Design Review Committee

Case 20746 – 1663/ 1665 Barrington Street,
Halifax (former Little Mysteries)

Paul Sampson, Planner II

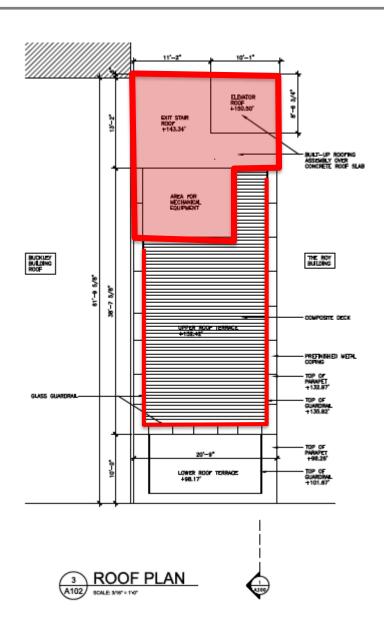
Areas of Non-Compliance:

- 49% instead of 30% of roof area;
- No setback for mechanical/ stair/ elevator enclosures (3m required from outer edge of roof);
- 0.45m setback for glass guard rail (instead of 3m)

Variance Rationale:

(Design Manual, 3.6.8 a & b)

- No increase in floor area;
- Small lot/ footprint of building;
- Minimal visibility of roof features

Land Uses at Grade (ground floor height)

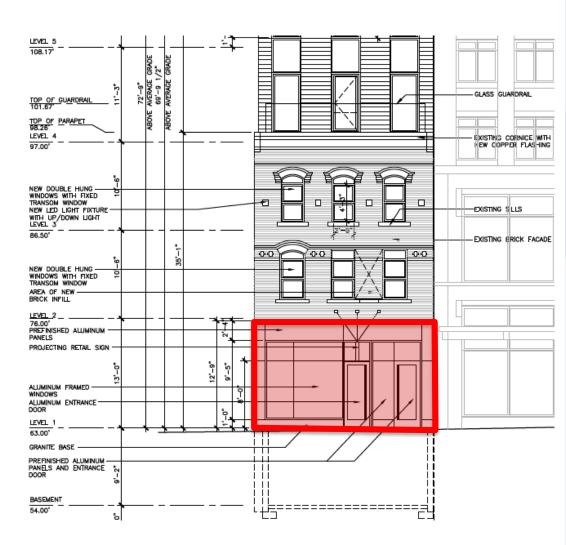
Areas of Non-Compliance:

4m (13 ft.) ground-floor height instead of 4.5m (14.75 ft.)

Variance Rationale:

(Design Manual, 3.6.15 a, b & c)

- Retention of existing façade and portion of floor/ walls;
- No sunken ground-floor condition;
- Minor reduction in height
